SECURITY FACTS

A Physical Security Technology Newsletter

VOL. 7
NO. 1

CORRECTION TO ARTICLE IN SECURITY FACTS NEWSLETTER, VOLUME 6, NUMBER 2

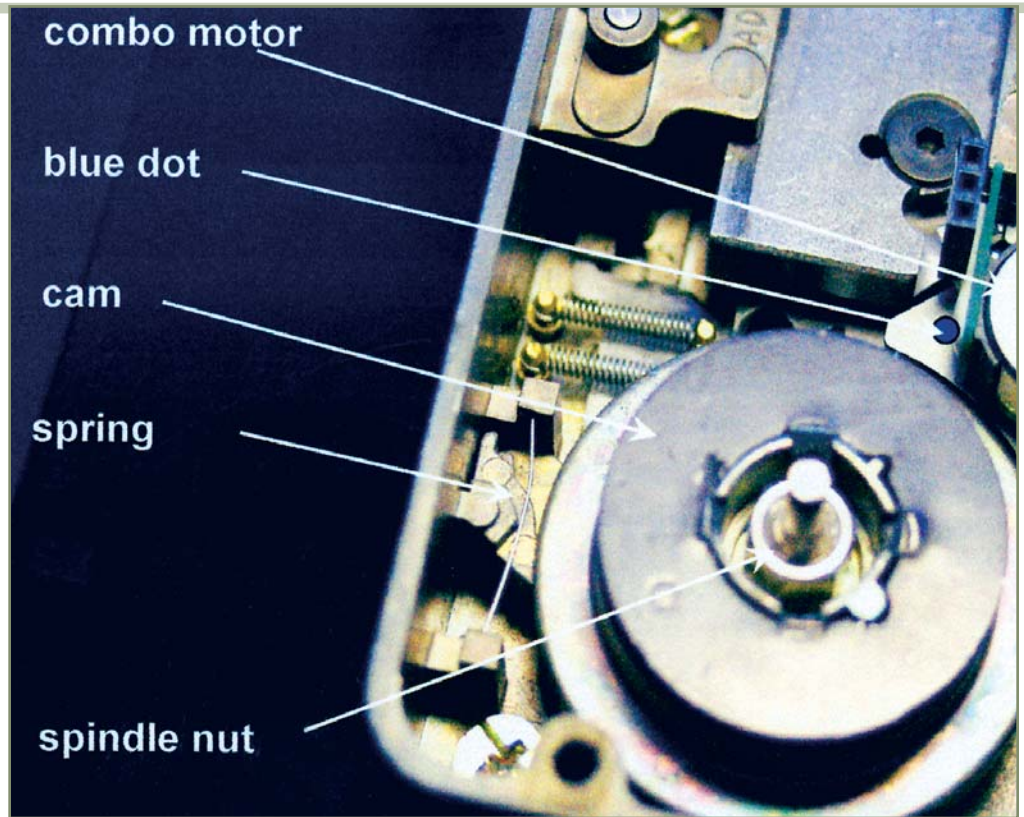
An article in the Spring 2003 issue (Volume 6, Number 2, page 4) of "Security Facts" newsletter titled "What to do if you receive a container and the dial will not spin," contains an error. The article dealt with removal of the cam pawl and its spring from the X-09 combination lock. The photograph in the article incorrectly identified the cam pawl spring as a coil spring. **THAT SPRING SHOULD NOT BE REMOVED.** The cam pawl spring is correctly identified in this photograph.

Many of the locks that had cam pawls also had combo motors that should be replaced. (If a lock was manufactured without a cam pawl, its combo motor does not need to be replaced.) While you have the cover off the lock, check the combo motor. If there is no blue dot at the location shown by the arrow, and if the lock was manufactured in 2002, the combo motor should be replaced. Contact the DoD Lock Program to obtain a replacement combo motor. Removing the existing motor and installing a new one will require a T8 Torx wrench.

Here is the correct procedure for removing the cam pawl spring and cam pawl. Holding the dial with one hand, remove the spindle nut with a 5/16-inch nut driver. Remove the drive cam from the spindle. Remove the cam pawl spring and the cam pawl. Replace the drive cam on the spindle. Replace the spindle nut on the spindle. Turn the drive cam so the gear teeth are near the end of the lock case (at the bottom of this photo). Brace the tip of a Number 1 Phillips screwdriver against the gear teeth of the drive cam to hold the cam steady as you tighten the nut.
